DOCKETED	
Docket Number:	20-AAER-03
Project Title:	Amend Title 20 Computer and Monitor Regulations
TN #:	235621
Document Title:	California Investor Owned Utilities Comments - California Investor Owned Utilities - Comments re Proposed Amendments to Title 20 Computer and Monitor Regulations
Description:	N/A
Filer:	System
Organization:	California Investor Owned Utilities
Submitter Role:	Public
Submission Date:	11/16/2020 2:31:42 PM
Docketed Date:	11/16/2020

**California Investor Owned Utilities - Comments re Proposed
Amendments to Title 20 Computer and Monitor Regulations**

Response to Express Terms for
**Amend Title 20 Computer and
Monitor Regulations**
20-AAER-03

Figure 1: Power measurements for three notebooks with cyclic behavior.

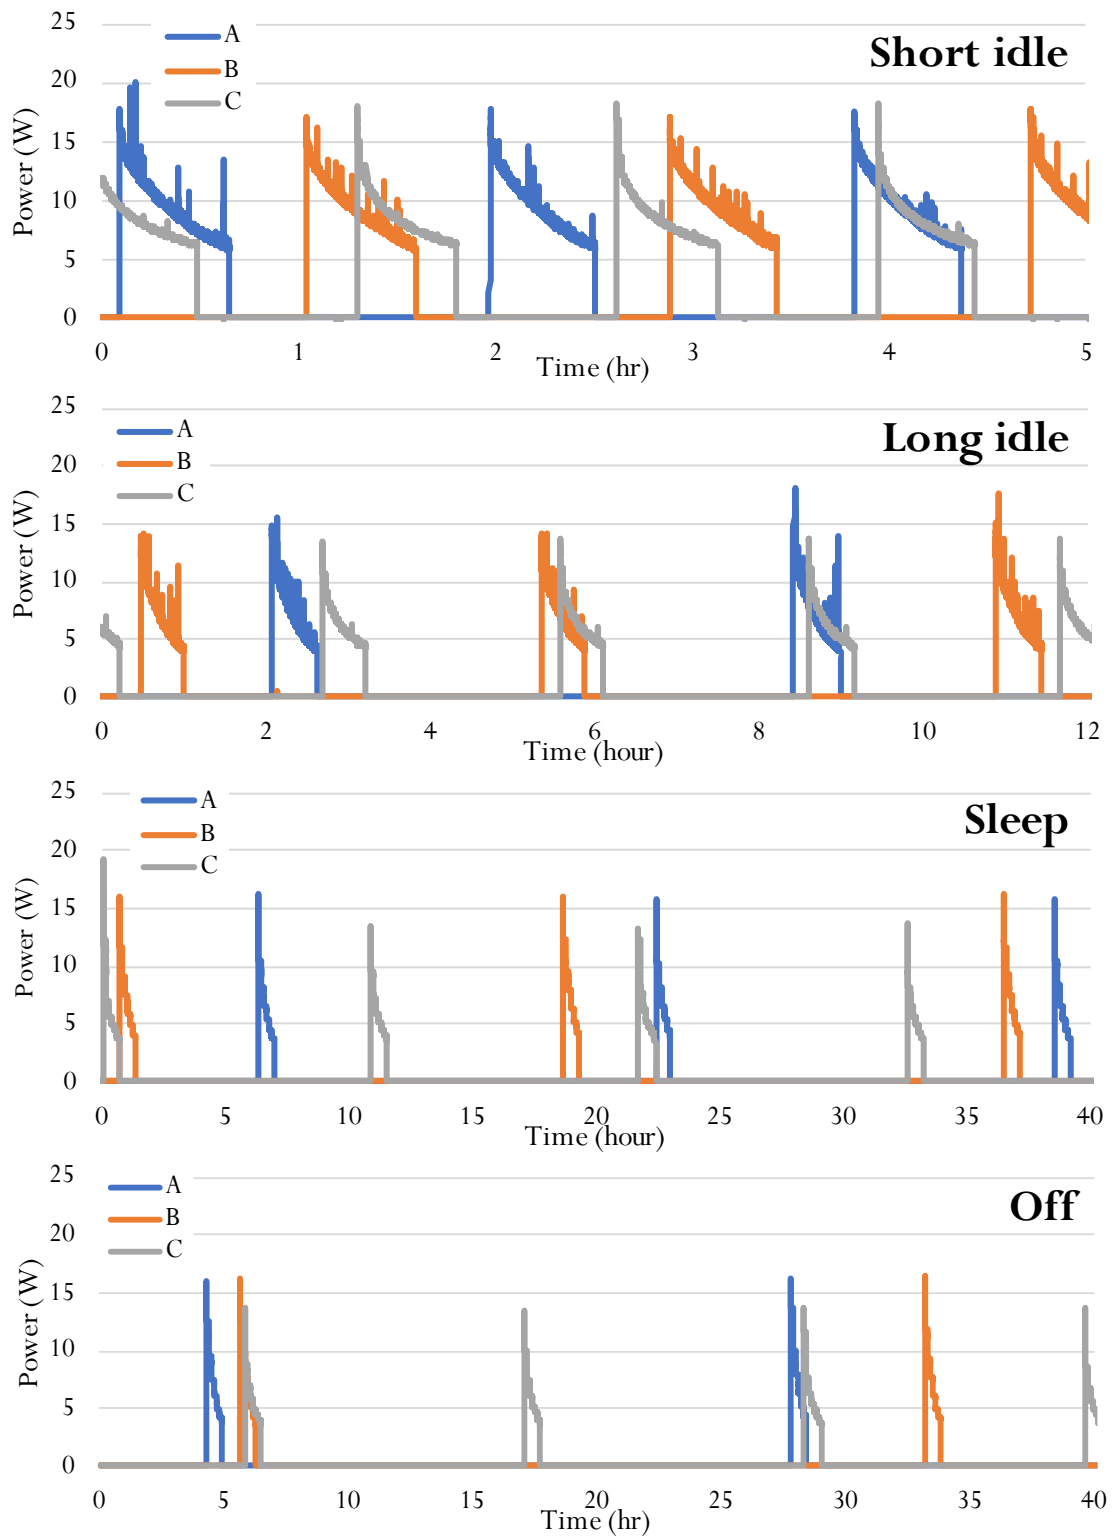
The Statewide CASE Team worked with an accredited lab to test three notebook computers identified by the computer industry as exhibiting cyclic behavior to test the proposed test procedure modifications and better understand the behavior. The Statewide CASE Team found that the proposed test procedure modifications were adequate to capture cyclic behavior. The cycles observed consisted of long periods of minimal power use (less than 0.1 watt (W)) and shorter periods of abrupt power increase followed by a decay in power, characteristic of a battery charge cycle as shown in Figure 1. This behavior was present in all four modes. The length of the cycles varied by mode, ranging from one to two hours in short idle to 11 to 28 hours in off as shown in Table 1. The notebooks performed similar charging intervals in their various modes of operation; charging intervals lasted about 30 to 40 minutes and consumed about four to five watt-hours (Wh) of energy.

Each notebook tested during this effort was able to operate without its battery. Tests conducted with the battery removed showed stable power use with no cycling, confirming that the cyclic behavior is related to battery charging. Average power draw with the battery removed was similar to the average power draw over a full cycle for each of the notebooks tested as shown in Table 1.

batteries be removed during testing if computers can operate without them. To test compliance of these models with the regulation, each of the notebook computers tested by the Statewide CASE Team would be tested according to the present test procedure, and therefore would not require testing of full cycles. Nonetheless, the Statewide CASE Team finds that the proposed test procedure for notebooks with cyclic behavior and unremovable batteries is adequate to measure average power draw of these types of systems.
